**GANDY MARLEY INC.**  
**NM-01-0020**

**AMENDMENTS**  
**Minor Modification**  
**Evaporation Pond**

RE: Gandy Marley Inc. NM-01-0020  
Amendment to C-137  
Minor Modification, Evaporation Pond

OCD Technical Review of Application for Minor Modification submitted April 12, 2006 Gandy Marley Inc. NM-01-0020. Proposed Brine Pond & Liner system application and layout drawing sheet 1/1 Falcon Environmental Lining Systems, Inc. dated 03/06/06 drawn by: JASMIN.

### PROPOSED BRINE POND & LINER LAYOUT

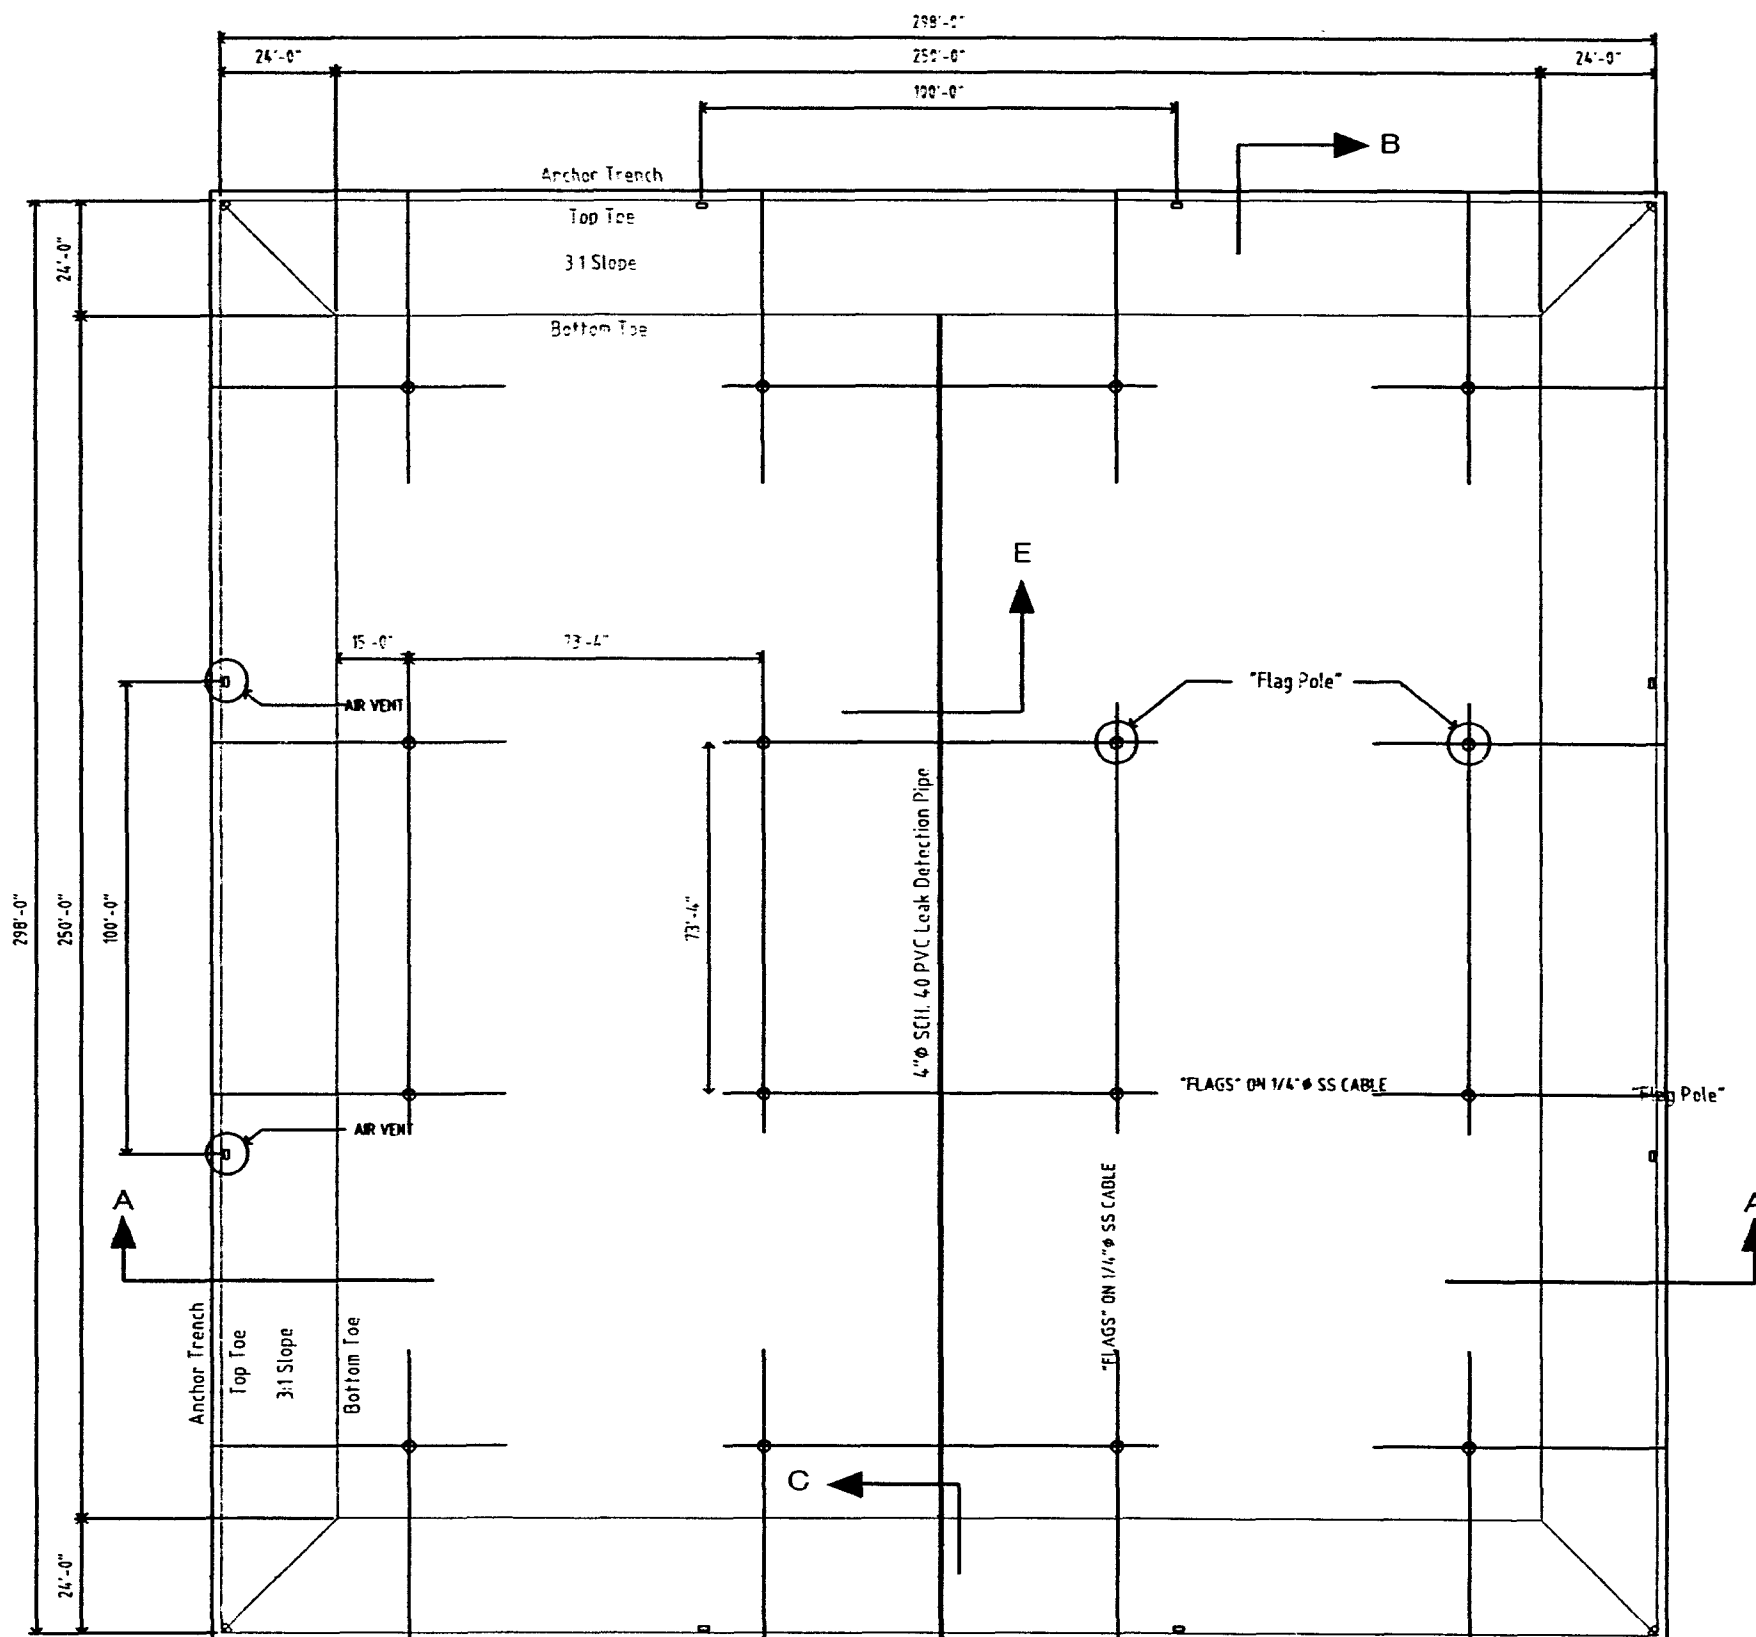
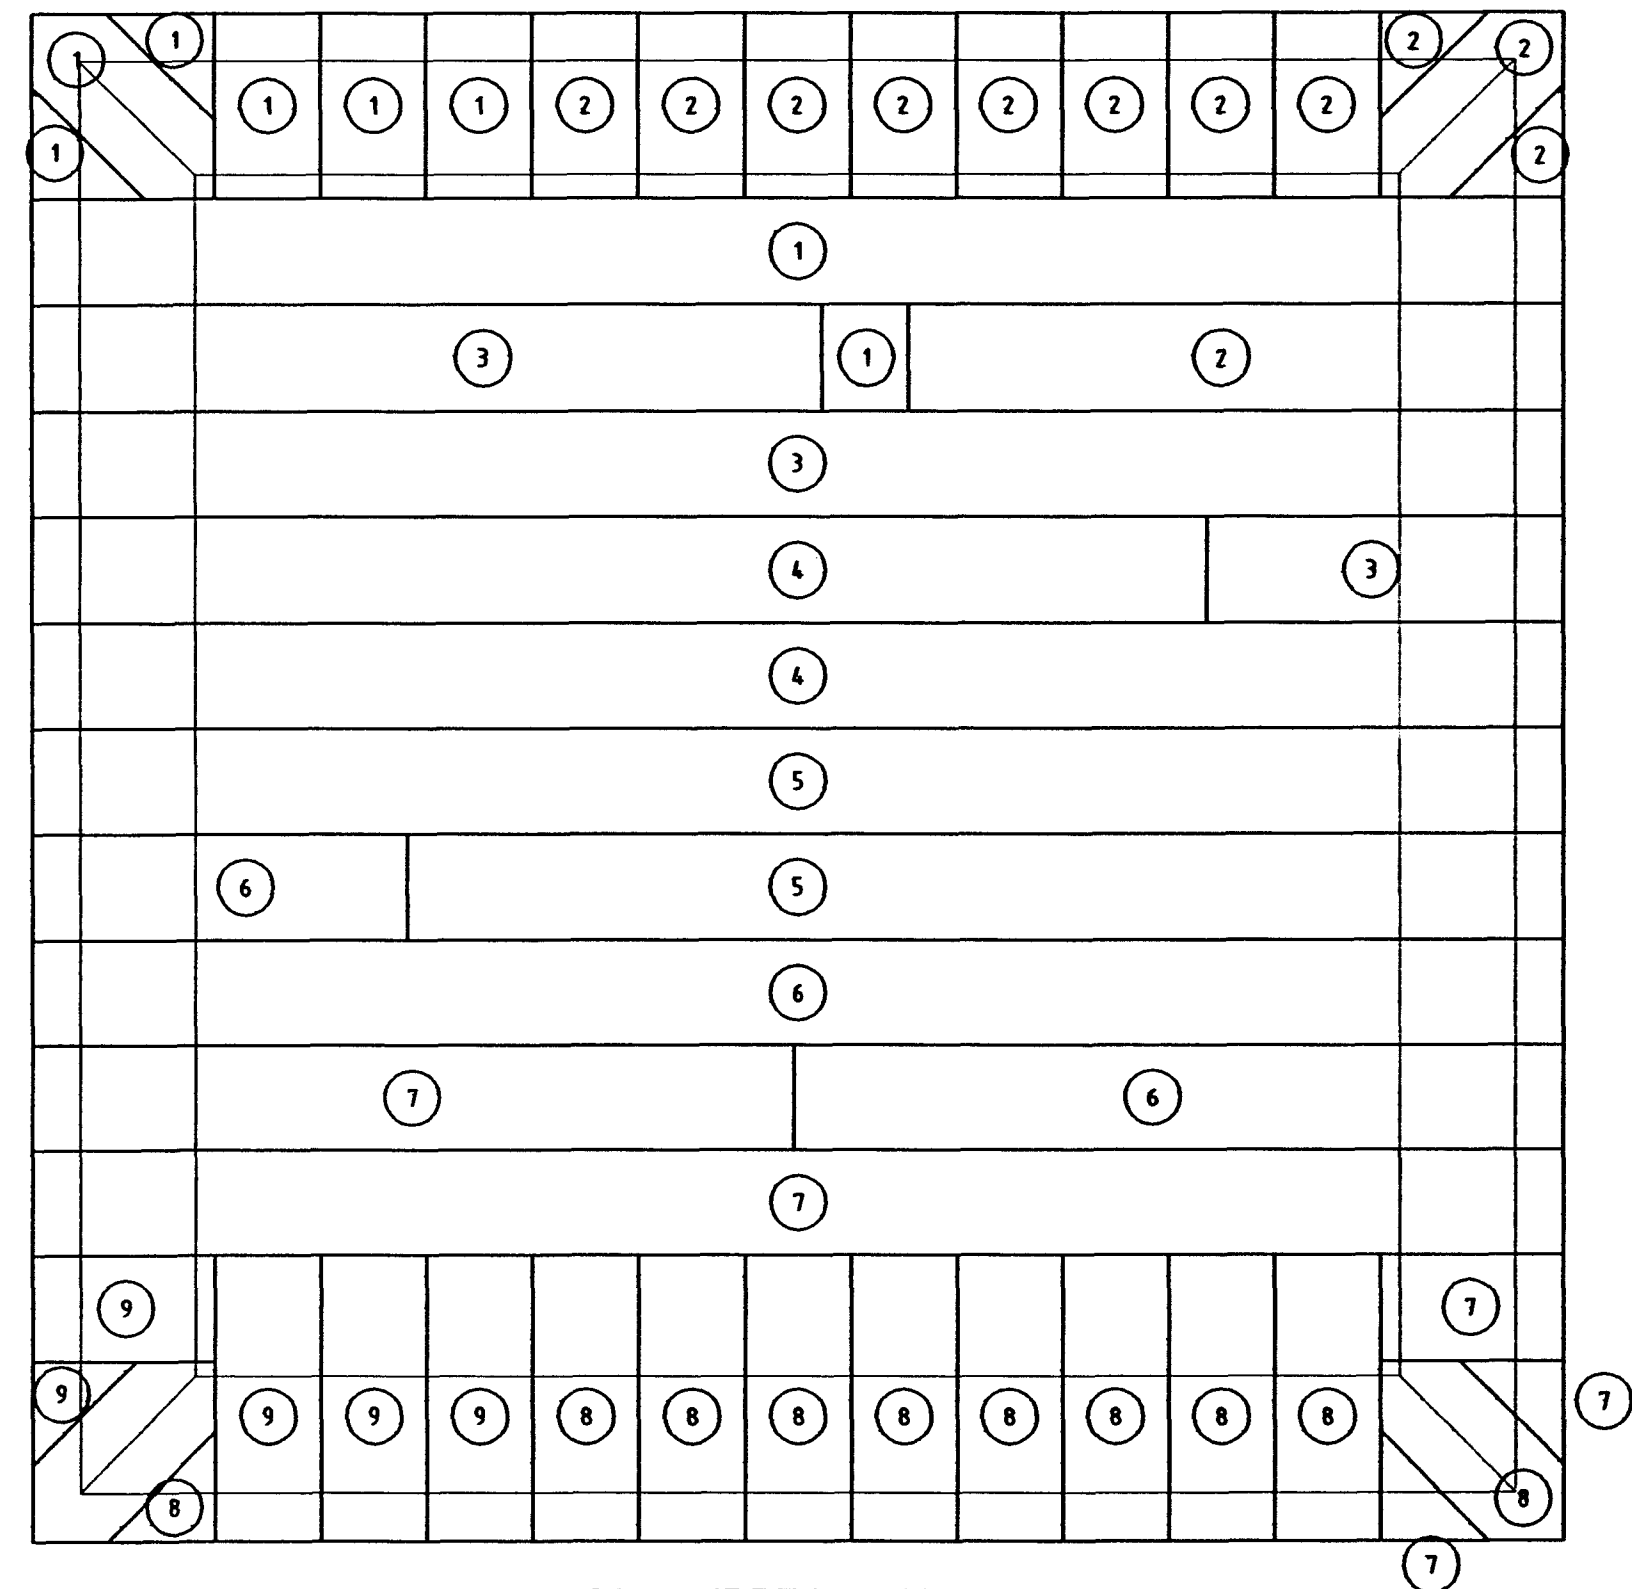
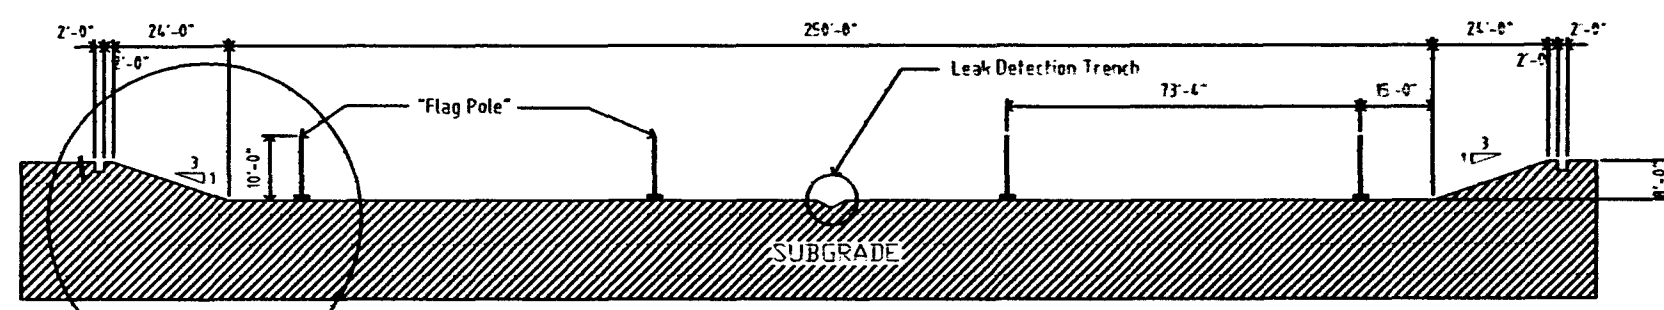
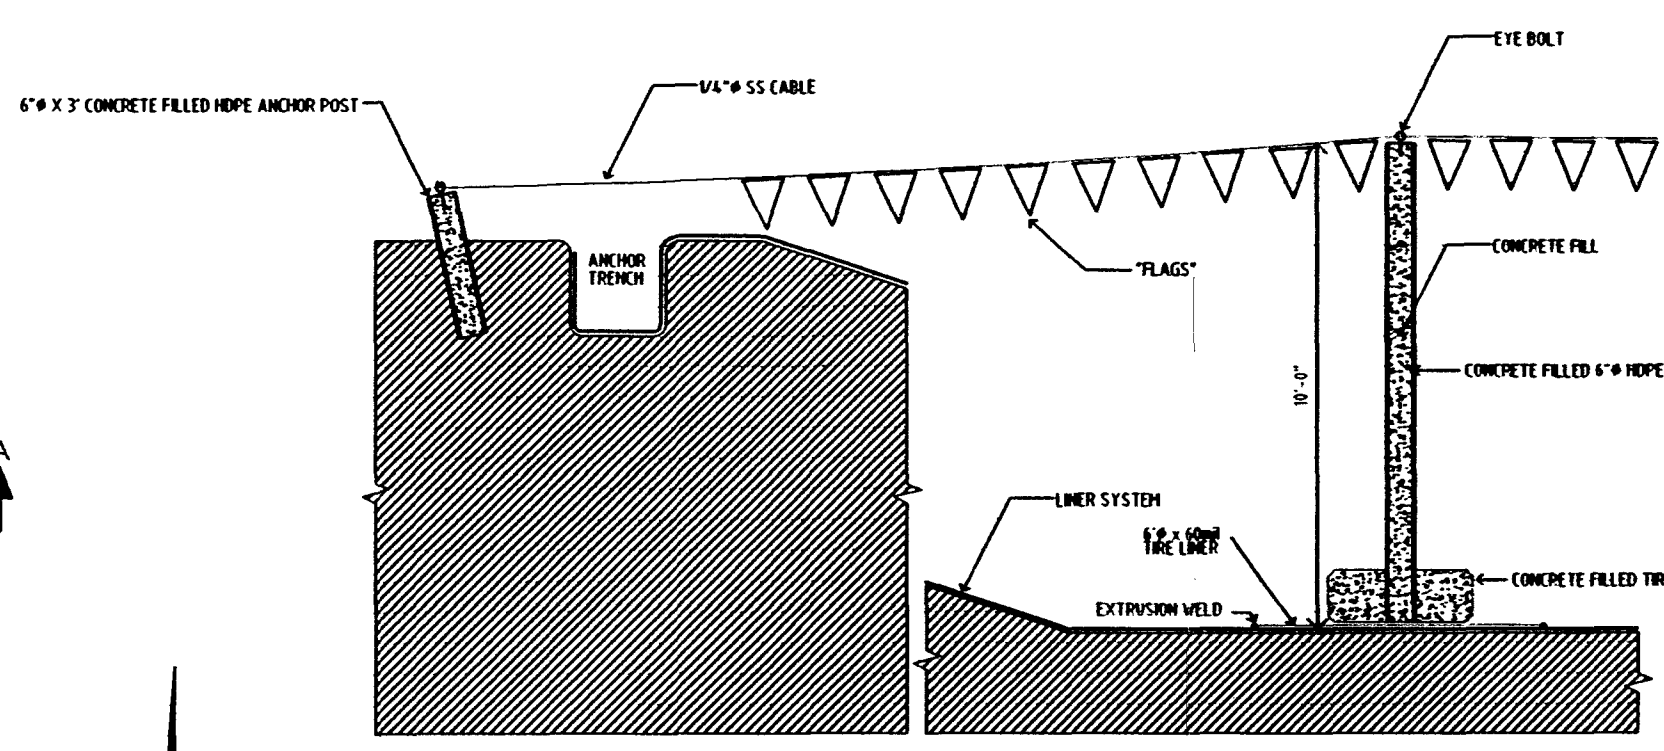
3. The drawing submitted was not checked by a representative of Falcon or design engineer. There was no scope of work, construction or material specifications, quality control plan, or testing program provided.

4. There was no liner and geo-net product information provided.
5. Please provide information that schedule 40 PVC pipe will withstand the structure and hydrostatic loading of the system. The 4 inch leak detection pipe does not appear to be sloped. There is no product information on the slotted pipe. Is there a way to check if pipe has been plugged and a way to clean it out?

8. The drawing did not show the external leak detection sump. The application did not adequately address how fluids in the pond and leak detection will be tested and for what parameters. The leak detection sump should be designed to be able to check total volume of leakage and installed with a sump pump or other fluid removal system.

- 1) I have attached a new C-137 form signed by Mr. Larry Gandy, Vice President of Gandy-Marley. Also, a letter is being sent to the OCD designating Eddie W. Seay as agent for Gandy Marley.
- 2) The proposed pond is located between cells 1 and 6, all within the permitted landfarm area. I think the old plat plan was unclear. We have supplied new map showing pond location. (Attachment 1)
- 3) (Attachment 2) A signed and certified copy of the drawing by Falcon's Engineer.

- 4) See Attachment 3, Product Data Sheet. This information covers all aspects of the geo-net liner.
- 5) Gandy Marley has decided to use schedule 80 pvc piping for its leak detection laterals. The 4 inch pvc pipe will be sloped at 1.2%. The pvc pipe will be perforated on location using four half inch holes per foot. The up gradient end of the leak detection pipe will be capped so we can remove cap and flush laterals with fresh water to ensure pipe is clear and all fluids are disposed of.

installed in the sump to put any accumulation of fluid into an onsite tank. The pump will have a meter built in to measure total volume of leakage. Any fluids that show up in sump will be tested for TPH, BTEX and Chloride.

# CEMENT CONTAINMENT SIDE VIEW

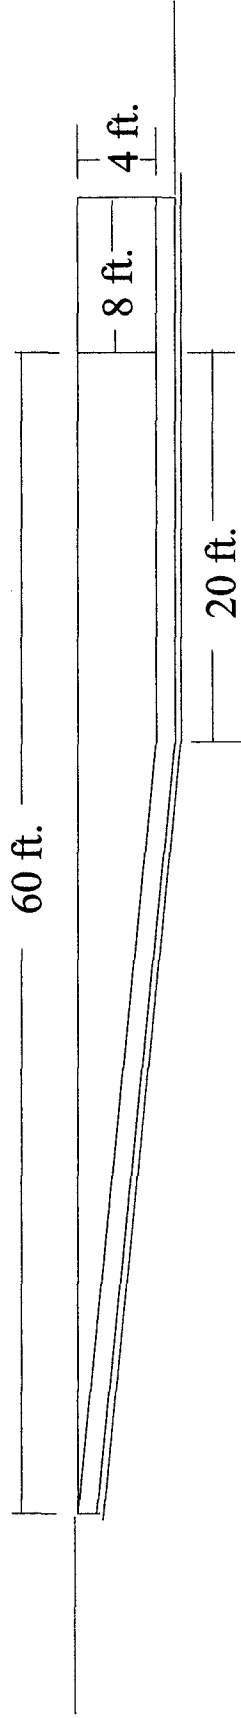
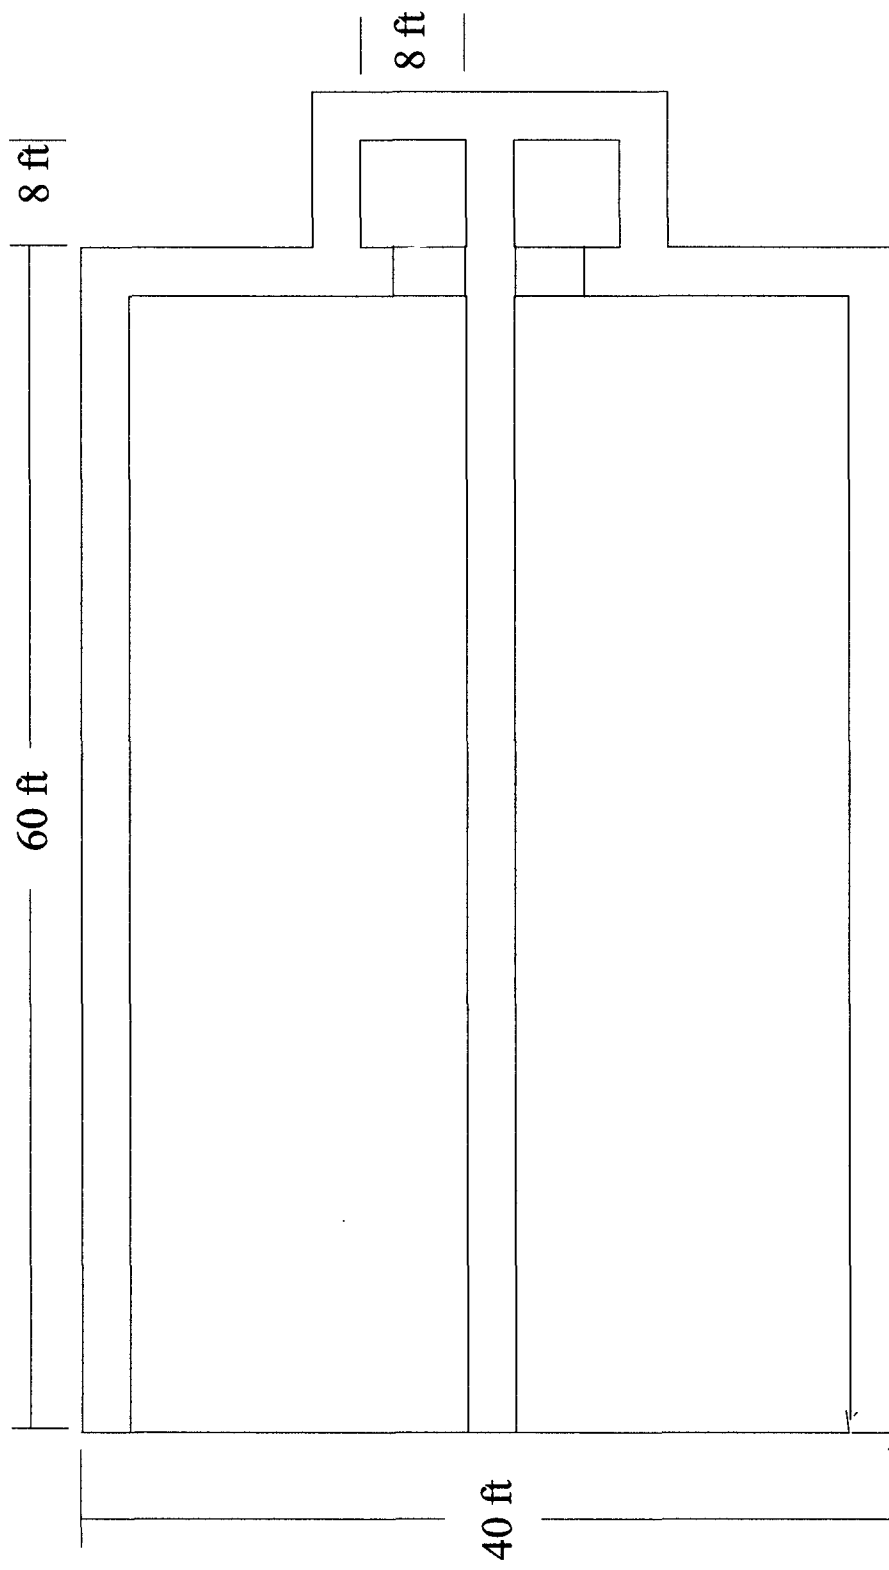
9. The application contained a drawing of a cement containment. There was no explanation for what this device is to be used for.
